Access Compliance Report

Public Rights-of-Way

(Curb Ramps)

Intersection ID: 10033987	Main Street: PARK_RD	Cross Street: N/A	Location: SW
ADA ID: 7E904C1895A6	Ramp Type: Directional2	Initial Pass/Fail: Fail	Overall Compliance: No
		Severity Score: 1.25

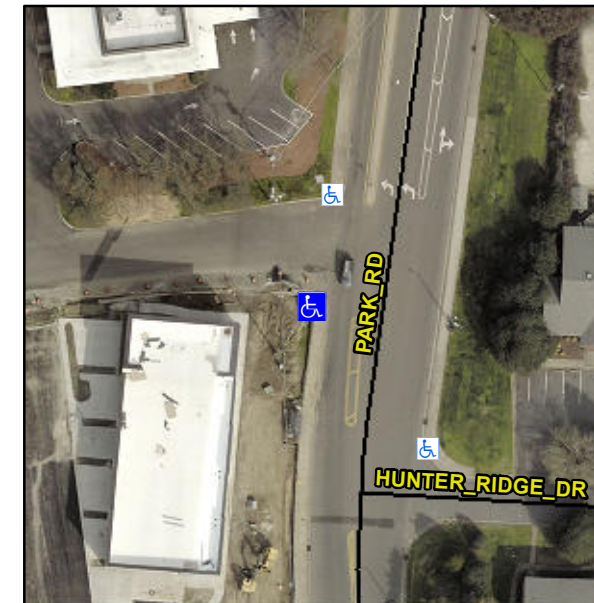
R304.5.3

Compliance	Description	Data	Compliance	Description	Data
N/A	Ramp Length (in)	64.0	N/A	Grade Break?	N/A
Yes	Ramp Width (in)	48.0	N/A	Grade Break Slope (%)	0.0
Yes	Ramp Slope (%)	1.4	N/A	Grade Break XSlope (%)	0.0
No	Ramp XSlope (%)	3.6			
N/A	Flare Type LT	N/A	N/A	Flare Type RT	N/A
N/A	Flare Slope LT (%)	N/A	N/A	Flare Slope RT (%)	0.0
N/A	Flare Traversable LT?	N/A	N/A	Flare Traversable RT?	N/A
N/A	Landing Length (in)	0.0	N/A	DWS Provided?	N/A
N/A	Landing Width (in)	0.0	N/A	DWS Contrast?	N/A
N/A	Landing Slope (%)	0.0	N/A	DWS Length (in)	N/A
N/A	Landing X Slope (%)	0.0	N/A	DWS Full Width?	N/A
N/A	Landing Curb? (Y/N)	N/A	N/A	DWS Offset LT (in)	N/A
N/A	Shared Landing?	N/A	N/A	DWS Offset RT (in)	N/A
N/A	Gutter Ponding?	0.0	N/A	Gutter Slope (%)	N/A
N/A	Gutter Lip Ht (in)	0.0	N/A	Gutter X Slope (%)	N/A
N/A	Painted X Walk1?	No		Road Slope (%)	1.1
	X Walk 1 Direction	To N		Road X Slope (%)	2.4
	X Walk 1 Width (in)	N/A		Clear Space?	N/A

Remove & Replace Entire Ramp.
